Urgent: Medical Device Correction

Update to September 2016 Field Action:

Important information regarding the Medtronic Model 37751 Recharger

28 February 2019

Figure 1

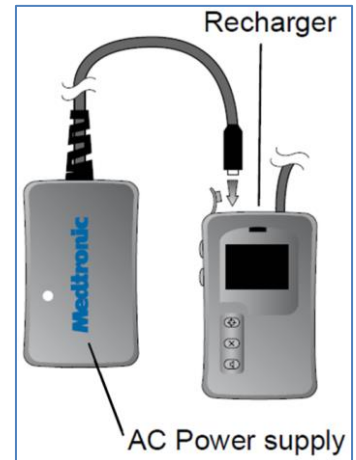
- To prevent this unresponsive error state, the Recharger should be plugged into the AC power supply (by aligning white triangles) prior to starting a recharging session of the neurostimulator and remain connected to the AC power supply until the recharging session has finished (see Figure 1). Note: The AC power supply does not need to be plugged into a power outlet if the Recharger is charged.

Follow the instructions included with the Charging System user manual shipped with the device. Instructions in the user manual do not require the Recharger to be plugged into the AC power supply for a recharging session to occur.
